# ADDENDUM #1

**Date:** August 8, 2019  
**City of Brookhaven RFP No.** RFQ 19-315  
**Project Name:** Briarwood Park Pool Project

**This addendum includes project clarifications, plan revisions due to permitting reviews, and responses to questions received by the Deadline for Questions (August 6, 2019 at 12:00 (noon) EST), .**

IMAGE 1

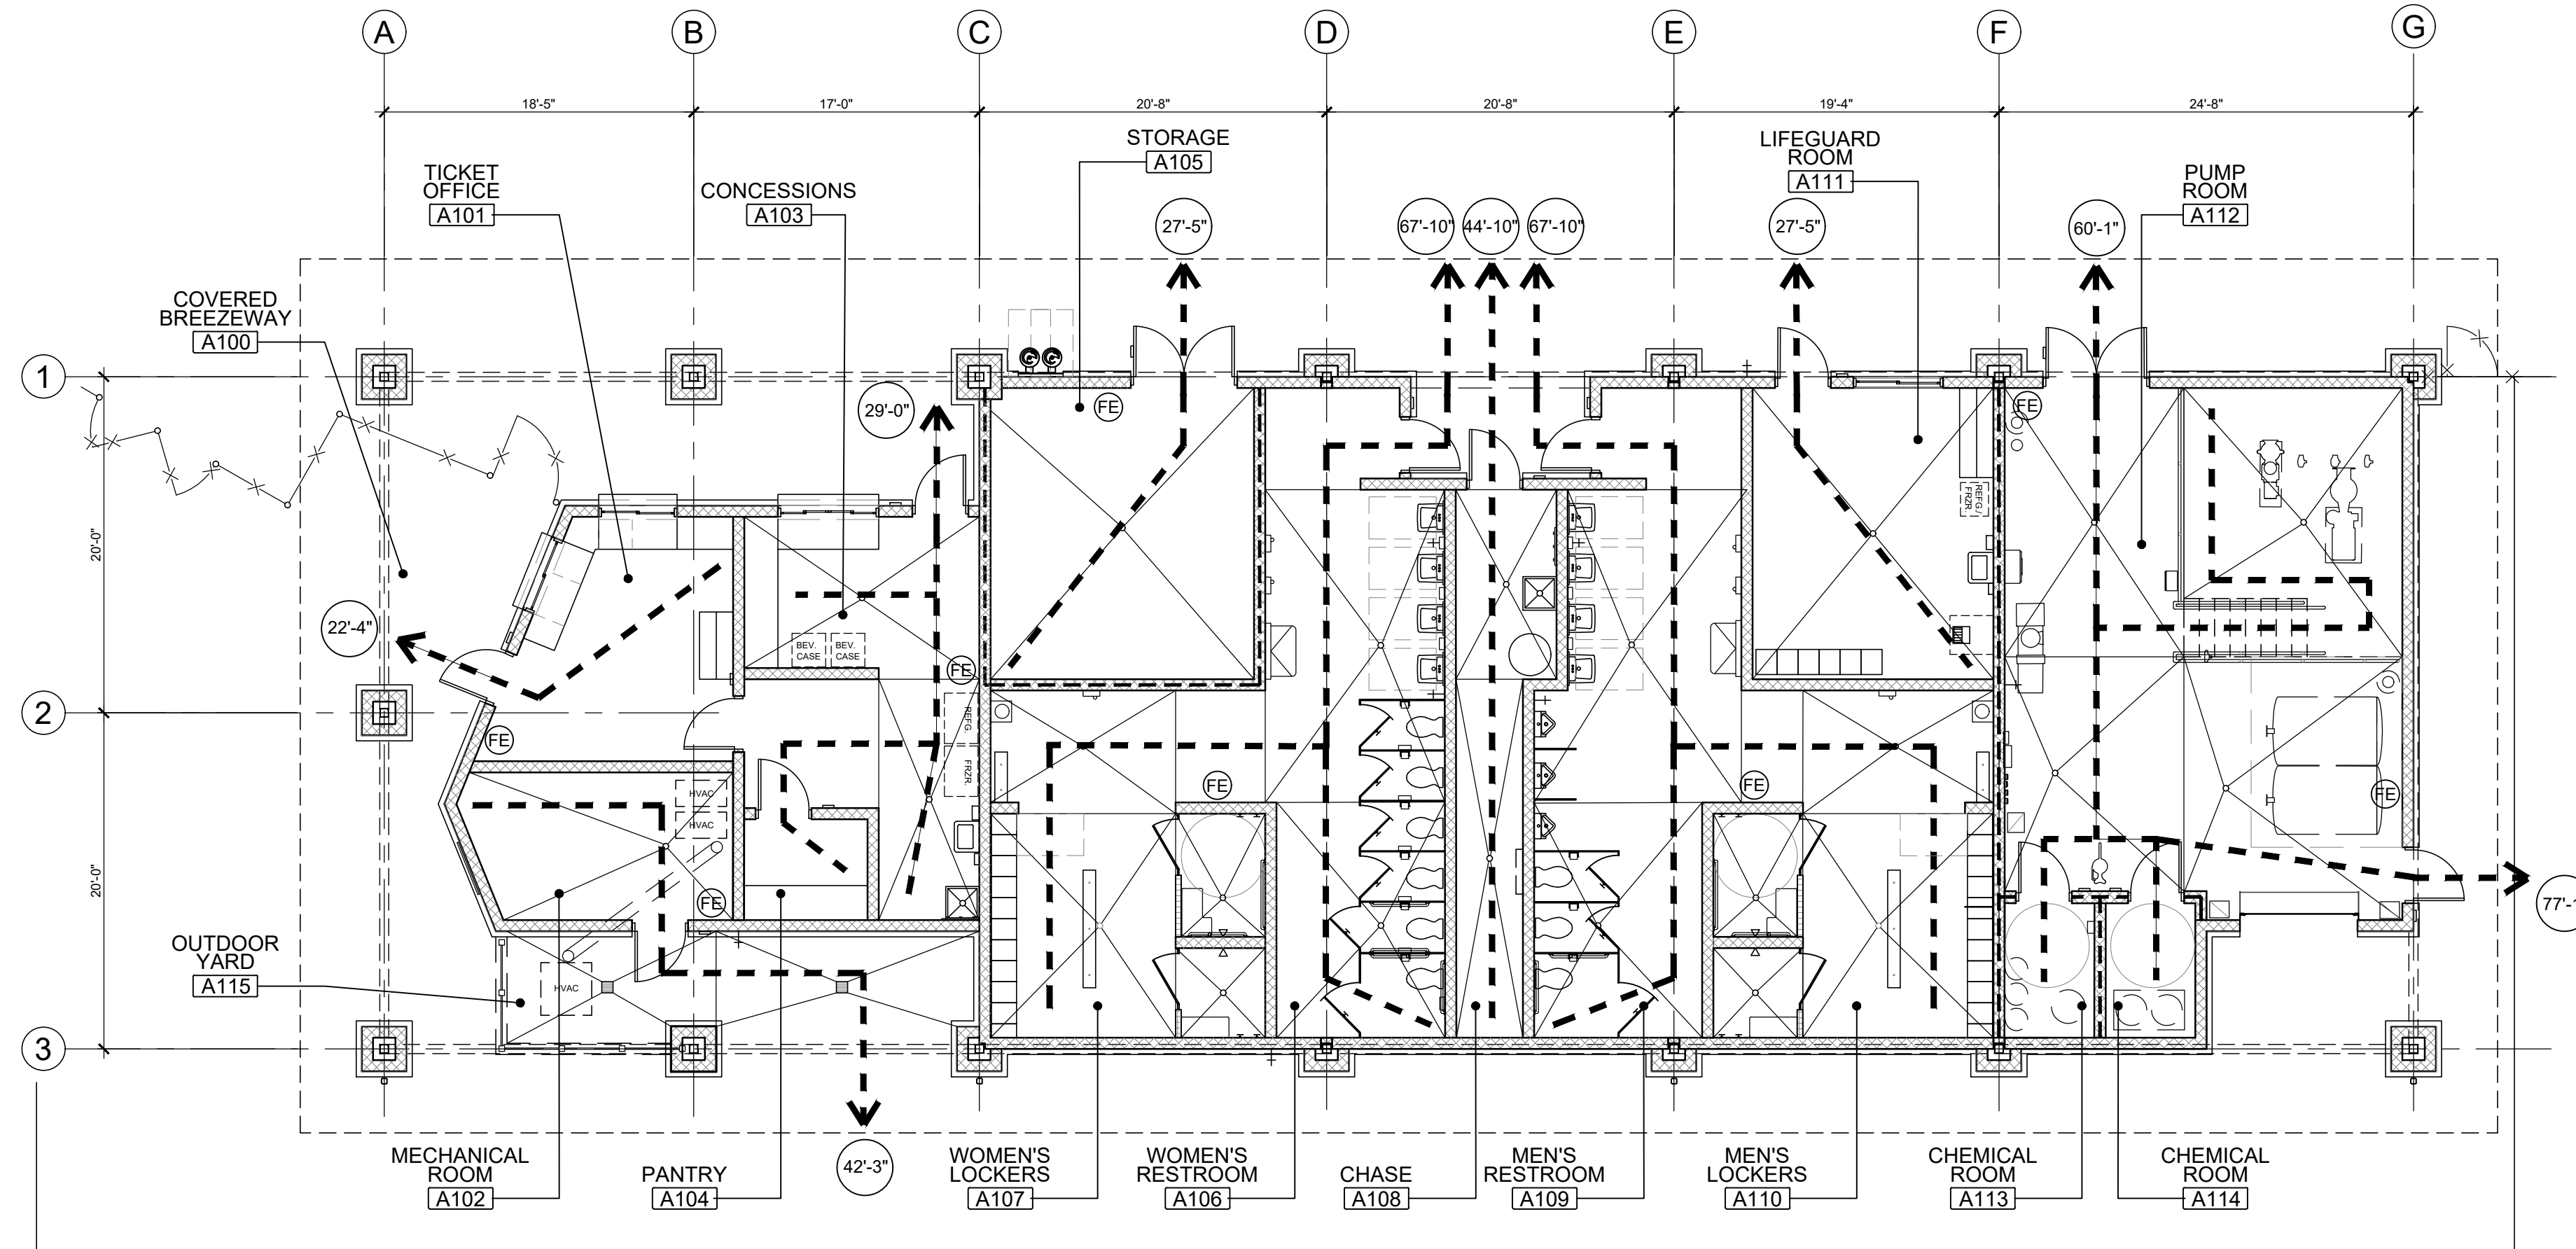
- k. Pumps in pool pumphouse (See attached Image 1)
2. Please be aware that several alternates are now listed as Deduct Alternates. **The TOTAL BASE BID should include these items and if they are not selected the TOTAL BASE BID will be reduced by the amount itemized for each alternate deleted from the project.**

PUMP TO BE SALVAGED BY OWNER

**A0.4**

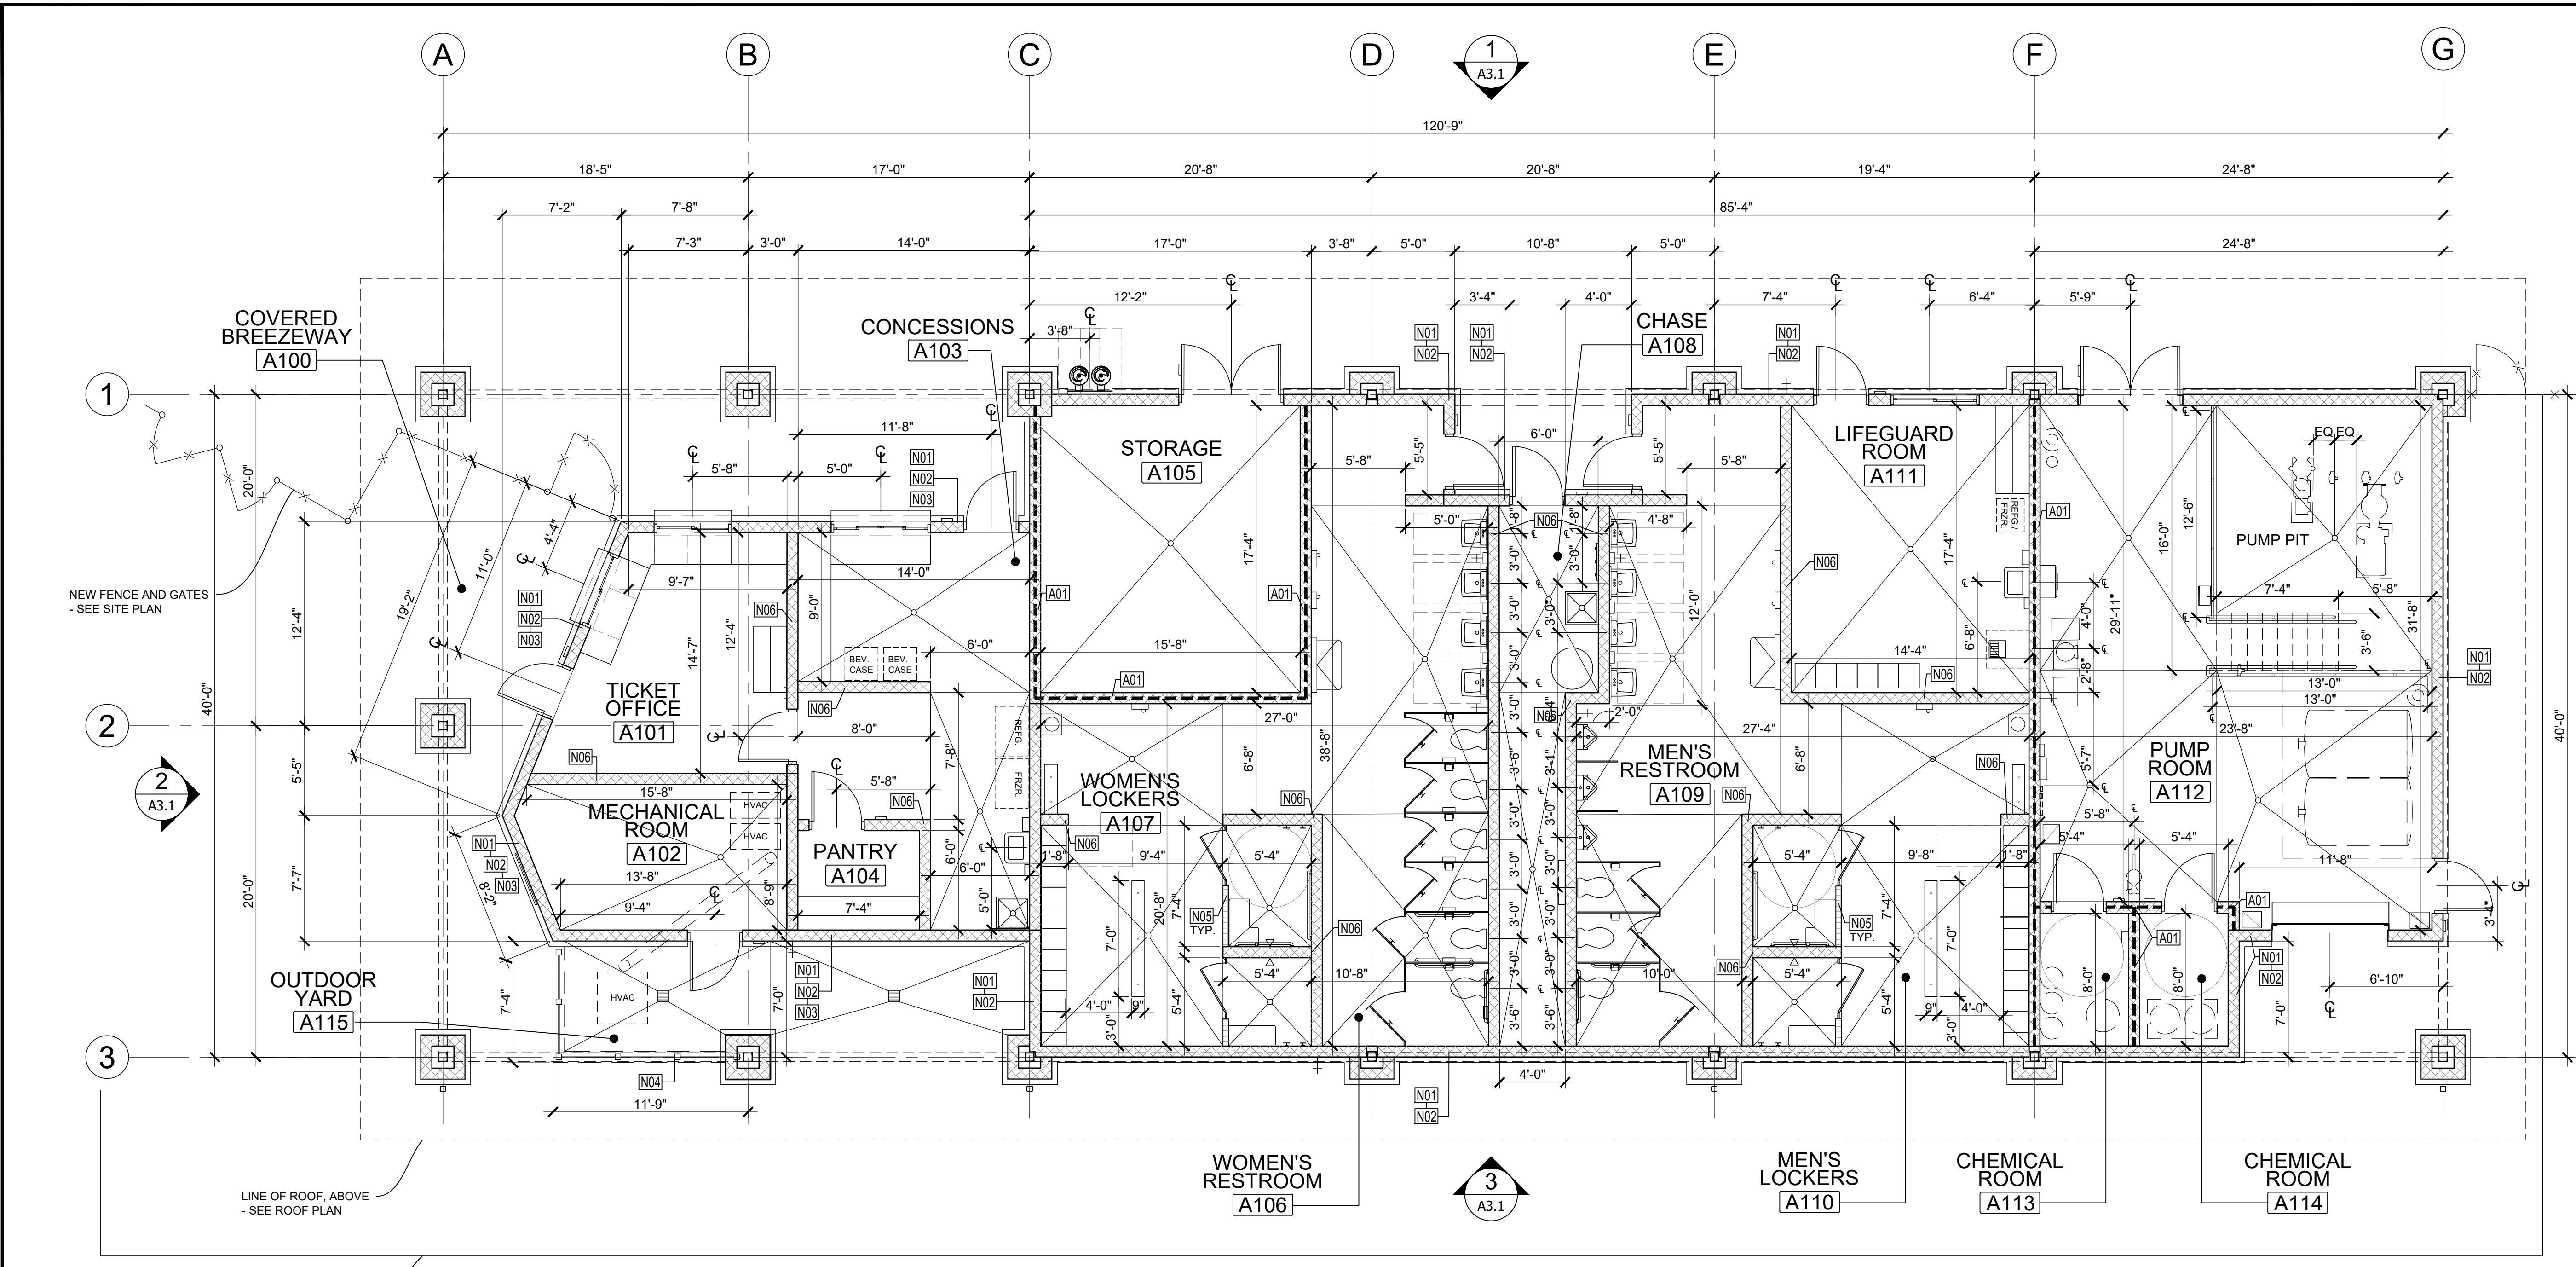
1. The following sheets have been removed and replaced to address a drafting error showing a duplicate water fountain. The revised sheets are noted with **A1 – 08/08/2019 – ADDENDUM 1 REVISIONS**
  - a. A0.4 – CODE REVIEW, COMMCHEC & LIFE SAFETY PLAN
  - b. A2.1 – FLOOR PLAN - DIMENSIONS
  - c. A2.2 – FLOOR PLAN - NOTED
  - d. A3.1 – EXTERIOR ELEVATIONS

SHEET NO. **A2.2**

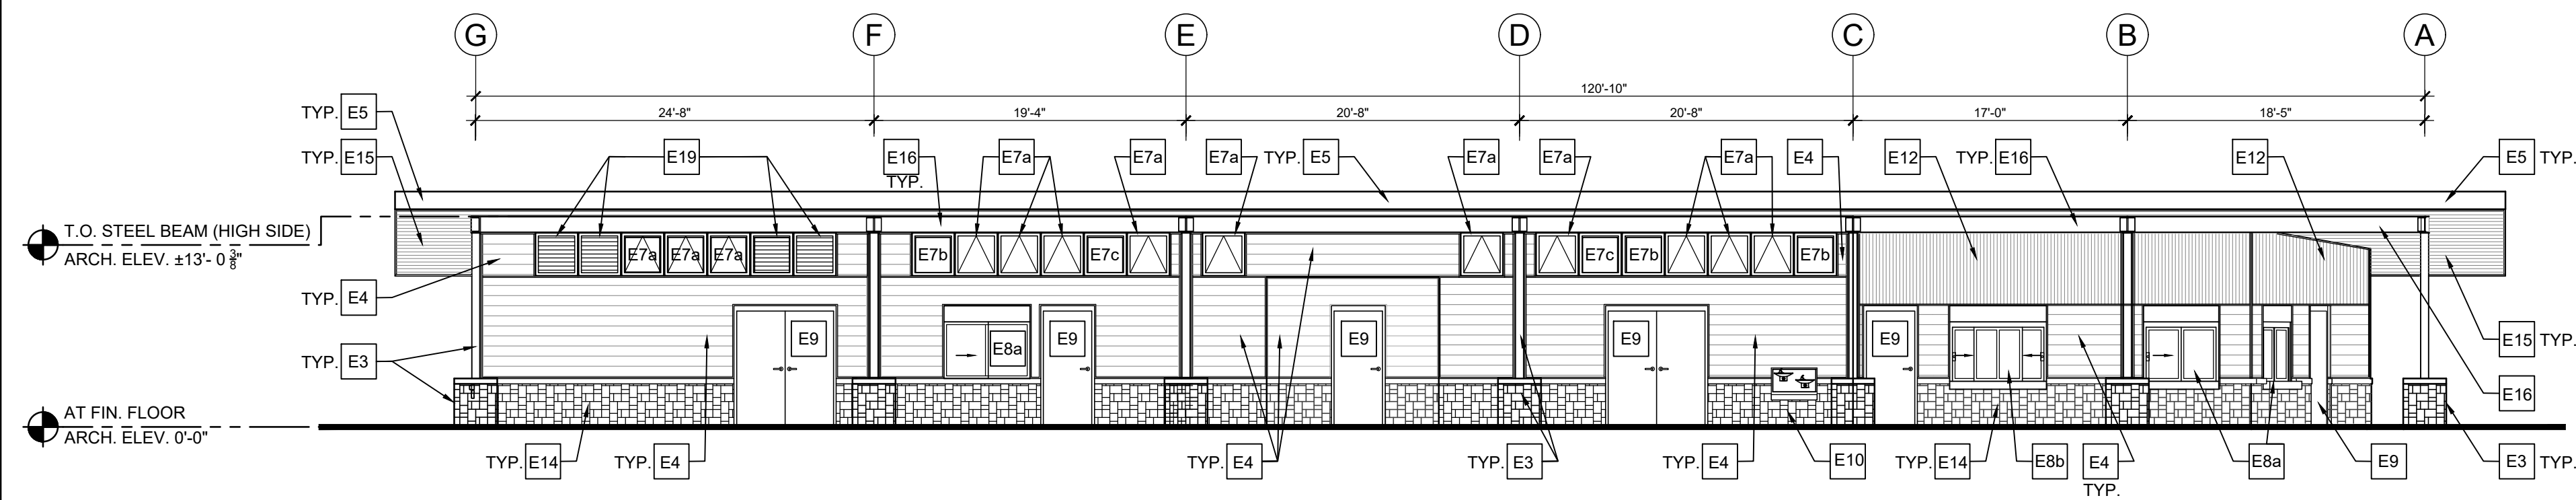
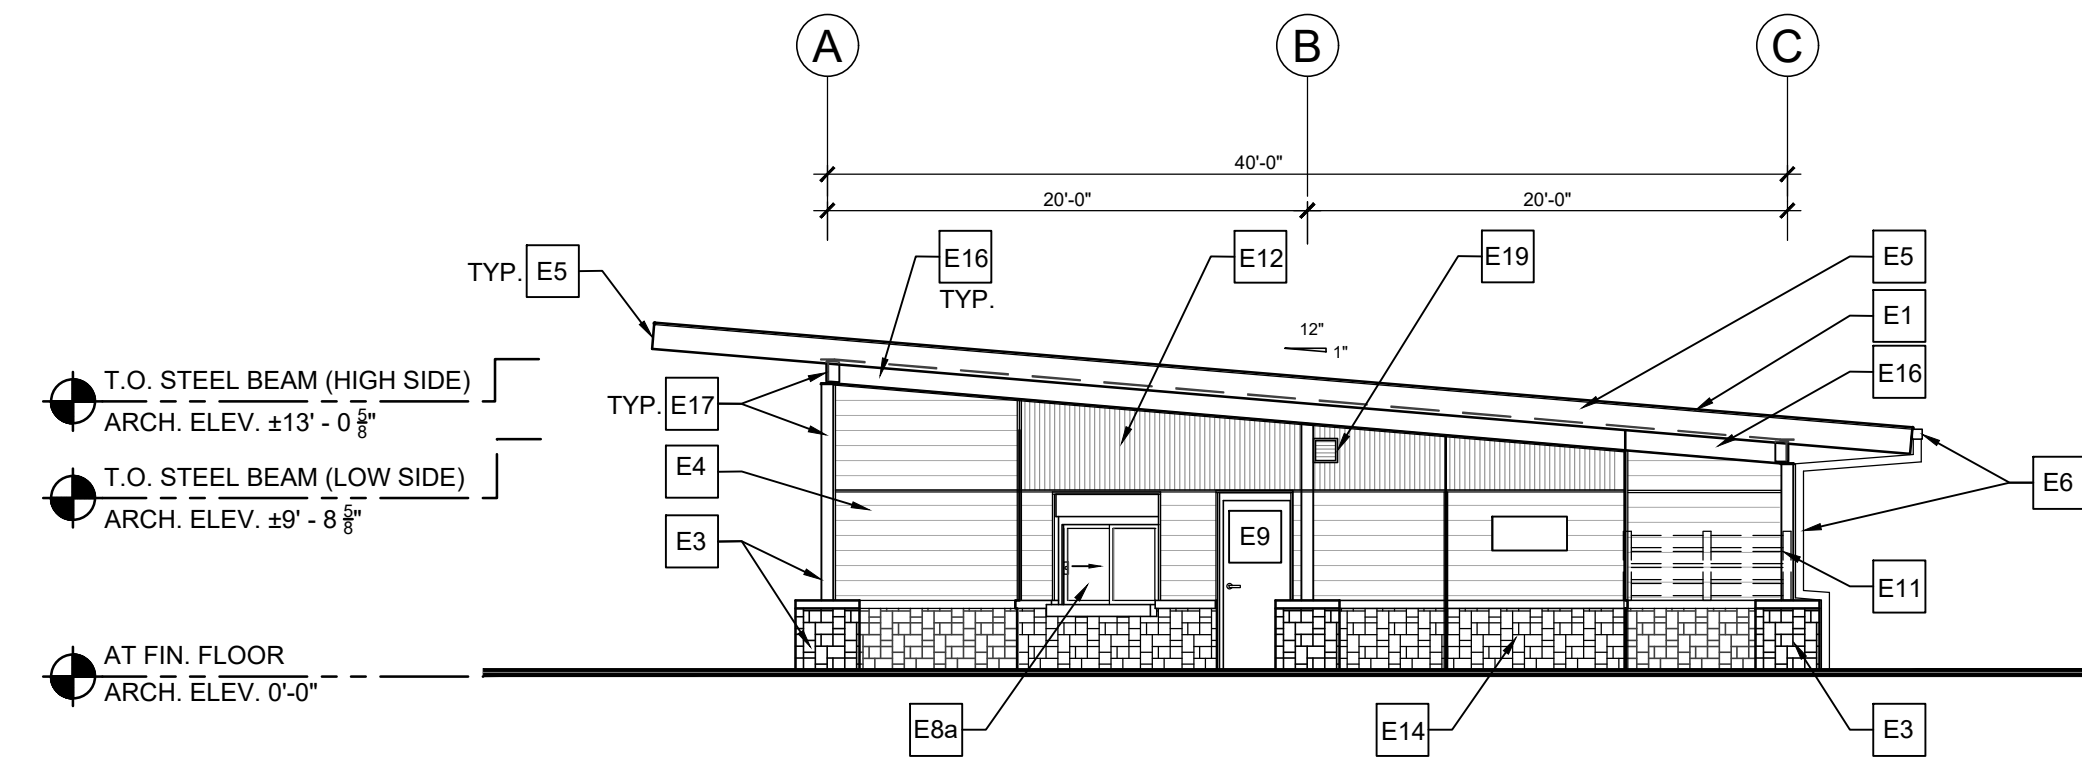
- a. *Yes. The Pool Contractor must provide evidence that they are certified or accepted by DeKalb County Board of Health within the RFQ response.*
- 38. The Floor Plan on A2.2 identifies the fence at Outdoor Yard A115 as "Alum. Picket Rail Gate & Fence". Detail 2/A4.5 describes this fence as "1x6 Cedar Wood Screen" with "4x4 Cedar Wood Posts". Please clarify which is correct?

- a. *Provide wood fence as referenced on A3.1 - E11 and Detail 2/A4.5. Reference on the Floor Plan on A2.2 that identifies the fence at Outdoor Yard A115 as "Alum. Picket Rail Gate & Fence" is incorrect.*
